Our ref: XA/2026/100502/06-L01
Your ref: EN020026
Date: 13/04/26 April 2026

Sea link planning Examination.

Annex 2: Flood risk issues update

Figure 1: Location of the Fromus crossing and the potential flood risk to the western approach road

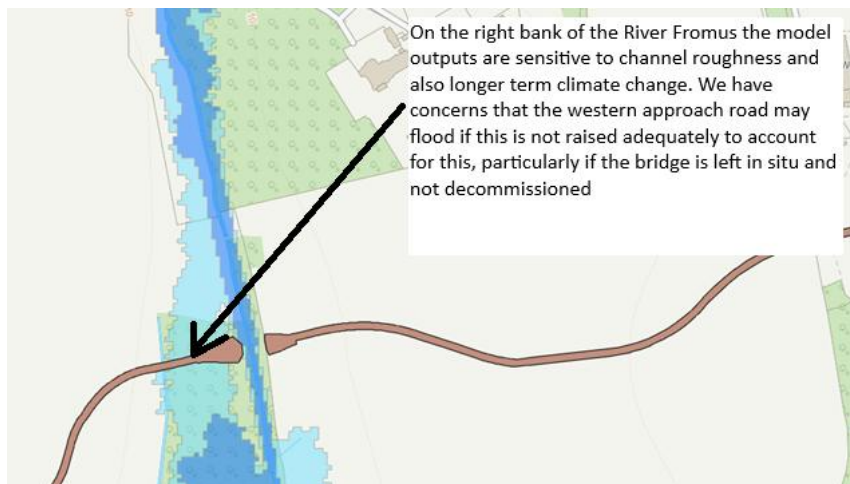
EA081 – Fromus bridge decommissioning

This relates to part b of the Exception Test.

This issue relates to the proposed crossing over the River Fromus in Suffolk (see map in figure 1 below).. The concern relates to the western approach road. We want to confirm that this road would be raised noting that it is modelled at existing ground levels within the hydraulic model. The reason for this is that the model outputs show the design flood extent in this location is sensitive to mannings roughness values. The flood extent is also sensitive to the climate change applied. With increased roughness and/or upper climate change allowances (which may materialise if the bridge is left in place indefinitely) the western access route could be affected by flooding. This should be raised to ensure it doesn't flood.

Following our meeting on 19/03/26:

Update the FRA to include the additional information presented characterising flood risk to the western approach road to the Fromus bridge.

Potential raising of road to ensure site remains operational.
Assured that applicant will maintain maintenance of crossing.
Applicant looking to retain crossing so further deliberation of appropriate design flood level related to proposed design life – suggested it could be in perpetuity.
